Hydraulics and Hydrology Memorandum

Date:	June 2, 2023
Project:	Monument Academy Recirculation Project
To:	Monument Academy
Cc:	Alissa Werre, PE, El Paso County; Cory Beasley, PE, HDR
From:	Elizabeth Staten, PE, HDR
Subject:	Hydrologic Analysis and Hydraulic Assessment

MONUMENT ACADEMY DRAINAGE MAPS PERMANENT WATER QUALITY			
Designer:	A.VANCE	Structure Numbers	
Detailer:	A.VANCE	Subset Sheets:	1 of 1
Sheet Subset:	WQ-MAP

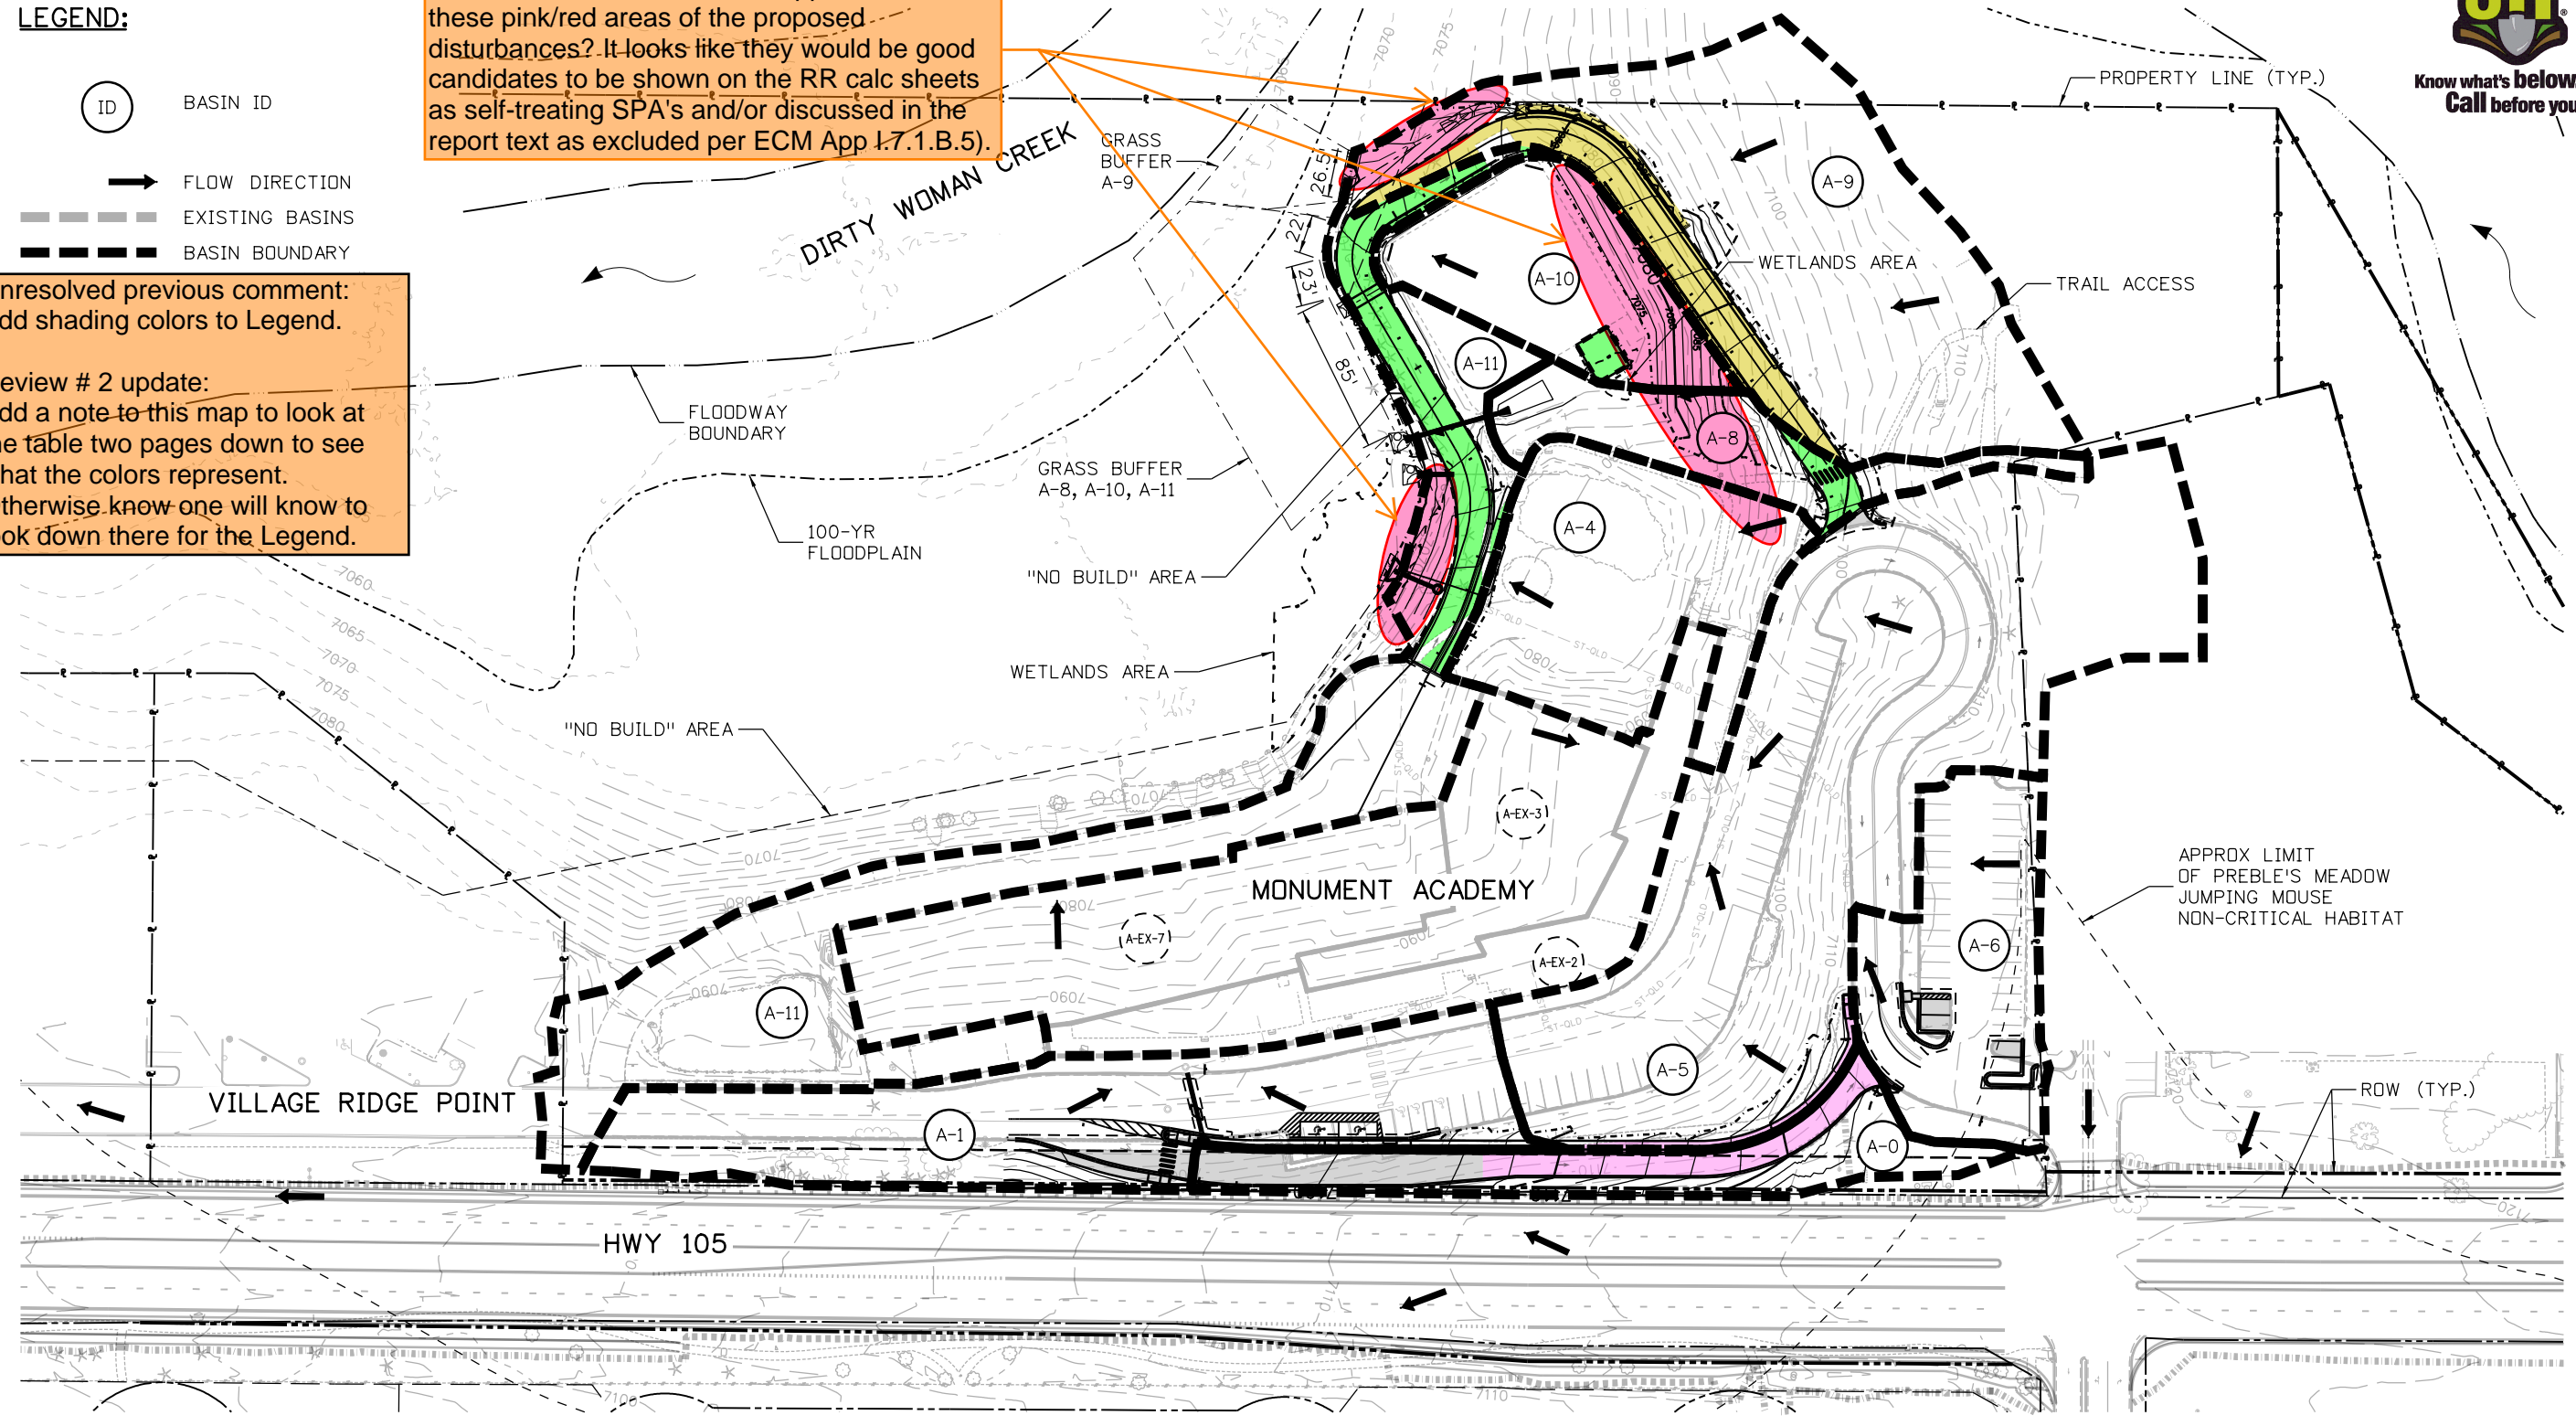
Unresolved previous comment:
Add shading colors to Legend.

Review # 2 update:
Add a note to this map to look at the table two pages down to see what the colors represent. Otherwise know one will know to look down there for the Legend.

Per my comment on pdf pg 64 below, what WQ treatment or WQ exclusion is applicable to these pink/red areas of the proposed disturbances? It looks like they would be good candidates to be shown on the RR calc sheets as self-treating SPA's and/or discussed in the report text as excluded per ECM App 1.7.1.B.5).
